Title: Advisory Committee on Reactor Safeguards
Plant License Renewal Subcommittee

Date: Tuesday, September 30, 2003

7 H.B. ROBINSON STEAM ELECTRIC PLANT, UNIT 2

RNP-SB0 Offsite Power Recovery

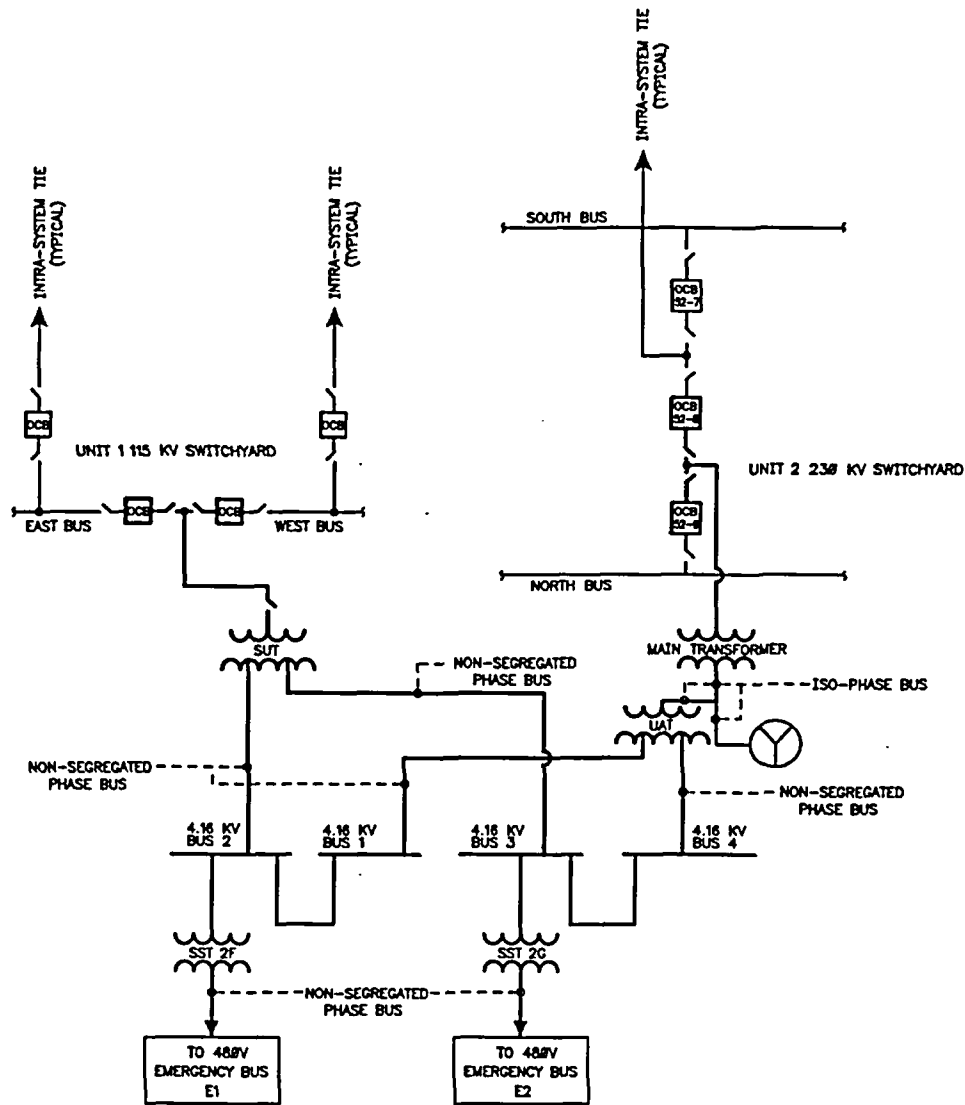
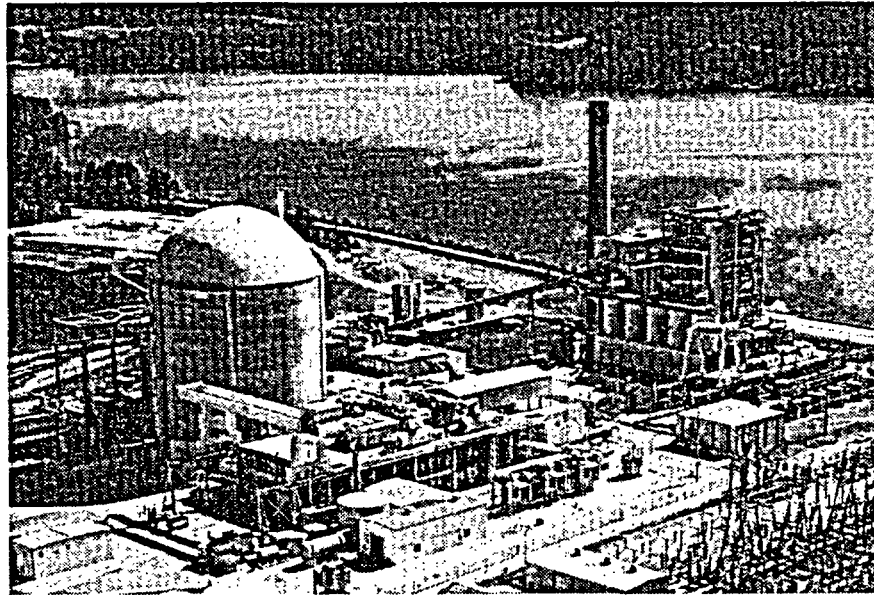
18 MR. ROSEN: Now before you get off this
19 slide, this is where my question was, about
20 Building 175, which is the switch yard relay
21 building, and the switch yard and transformer
22 itself. Are they now all in scope?

20 MR. ROSEN: Maybe if you step up to the
21 diagram and show us what's in scope and what's not.

18 MR. ROSEN: Okay. So your normal piece
19 on the Unit 1 slide, and that has now got two
20 breakers and some associated bus that are in scope
21 for license renewal for the nuclear plant.

1 got components of the nuclear plant's licensing
2 basis, it's a renewable licensing basis, that are
3 actually in the fossil switch yard, I mean, a
4 non-nuclear switch yard. Is that correct?

9 MR. HEATH: No, they're all together.
10 There's one switch yard. The Unit 1 side feeds
11 into the 115 KB. The Unit 2 side feeds into the
12 230 KB. It's all one switch yard. Typically
13 though, that's the separation, just which plant is
14 normally connected to which switch yard, which set
15 of the 115 KB or 230 KB. In other words, Unit 1
16 could shut down and it would make no difference to
17 Unit 2, as far as that switch yard is concerned.
